Preliminary Plat Checklist

PRELIMINARY PLAT

ANTLER FALLS

PUD-001242-2023

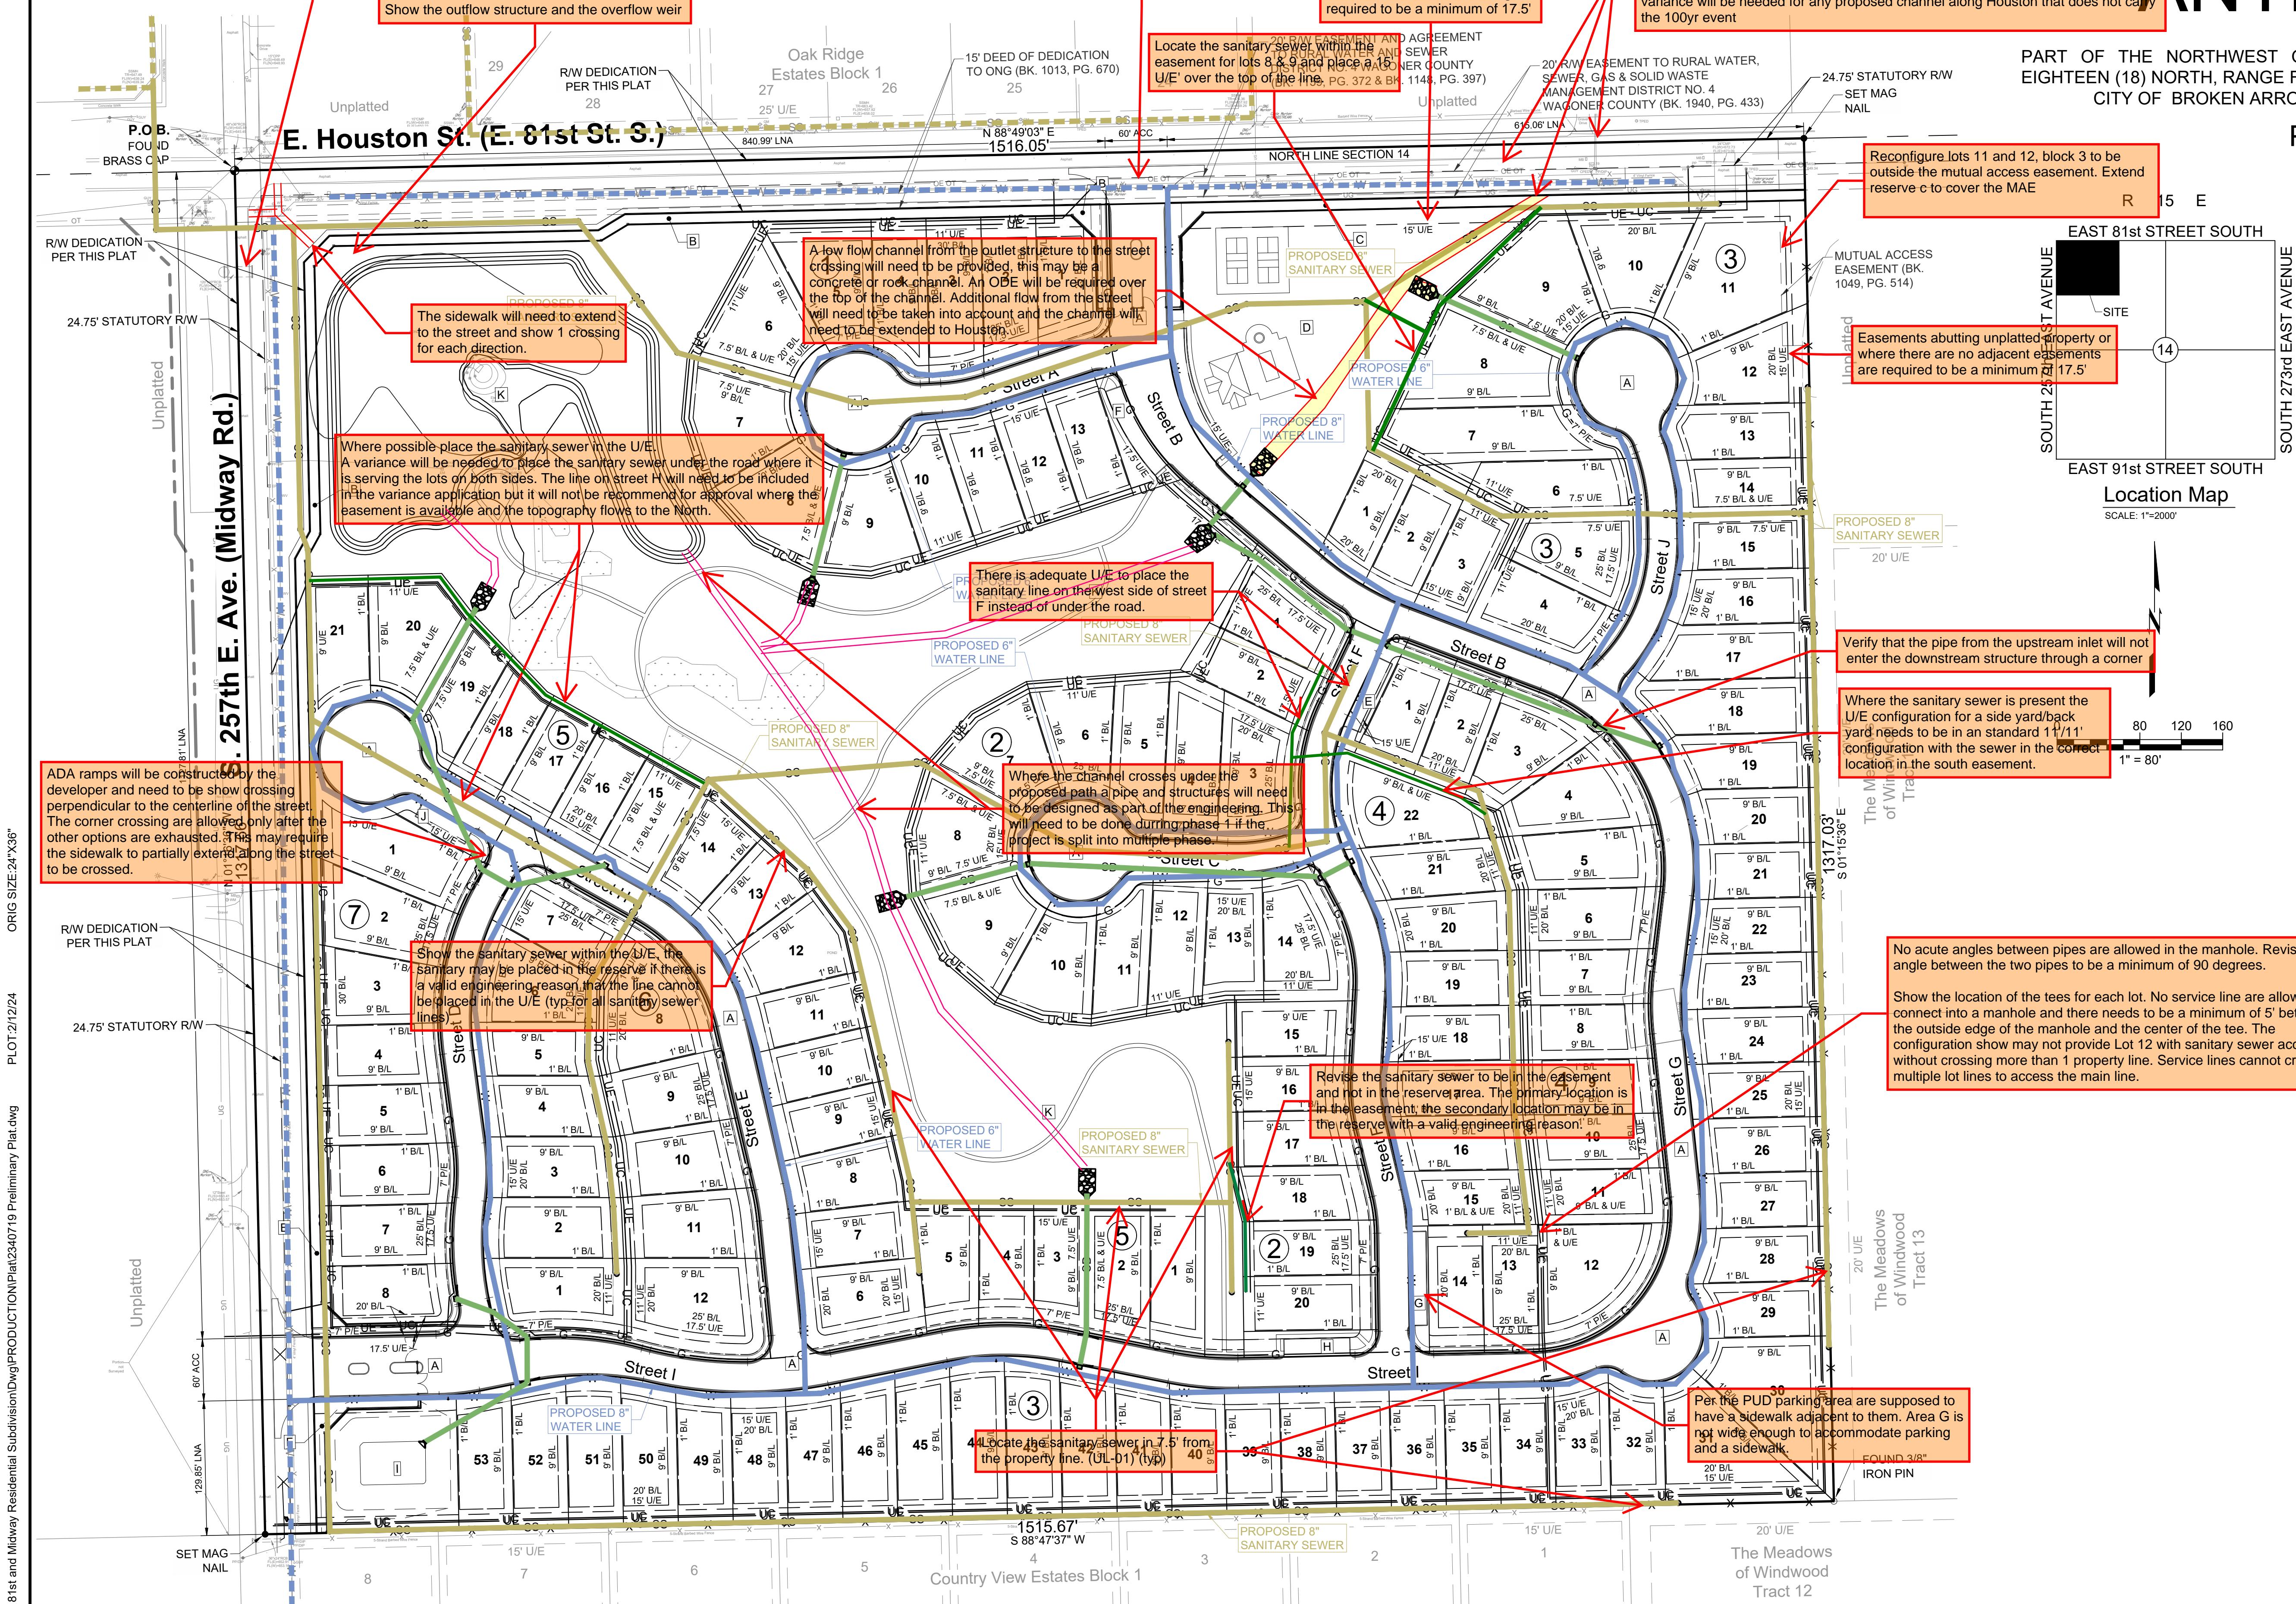
An analysis of the existing structure under the road will need to be completed and the volume that it can handle identified. Release from the proposed detention area and the street flows cannot exceed the flow that the box can accommodate. If the existing flow currently exceed the structure capacity we will need to discuss options with engineering and construction.
